FSA 25S39

Safety Recall 25S39 *Reissue 2*

Certain 2022-2025 Model Year Ranger/Everest 3.0L Lion Engine
Camshaft Sprocket Failure – **Final Repair**

NOTE: This supplement provides updated sprocket torque values and replacement procedure.

Figure 16A

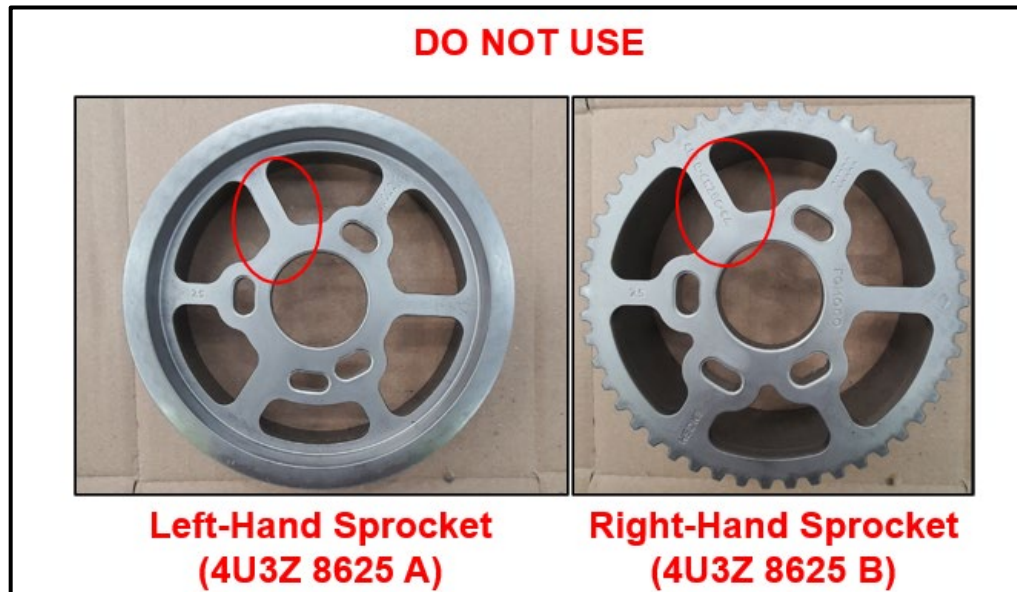
K. Install new crankshaft sprockets (ensure latest level sprockets are used, if old level parts are supplied return them to Ford PDC – Parts Distribution Centre, see below for pictures of new sprockets) and bolts. Figure 16A, 16B & 16C.

NOTE: Physical characteristics can be noticed on the old v/s new sprocket parts – circled. Hub and spoke of new design has additional material. Figure 16A & 16B.

Figure 16C

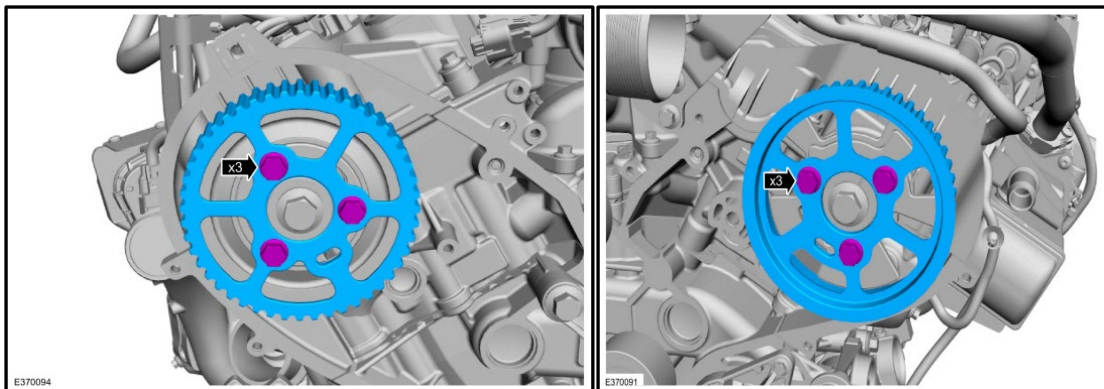
NOTE: If using pins 303-1670 these will have to be removed, to ensure the camshaft doesn't turn use a spanner to hold it, if using 5.9mm drill bits the sprocket will slide over without the need for removal.

Figure 21

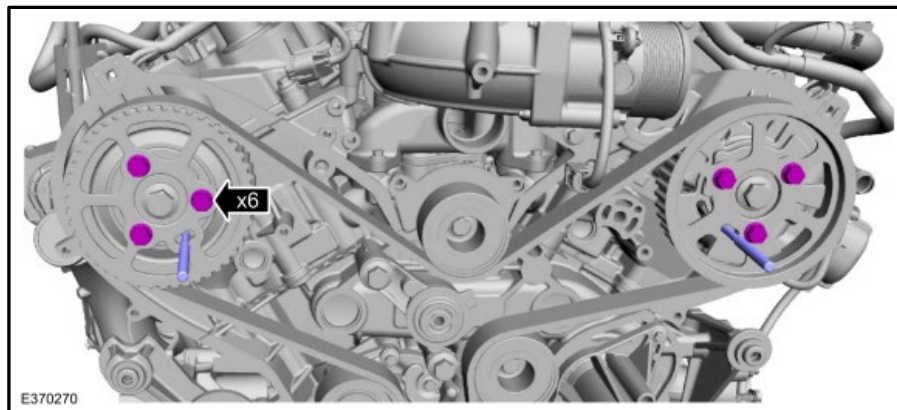
- O. *Tighten the camshaft pulley bolts. Figure 21.*
Tightening Sequence:
Stage 1: Torque to 10 Nm
Stage 2: Clockwise Rotation 35 Degrees
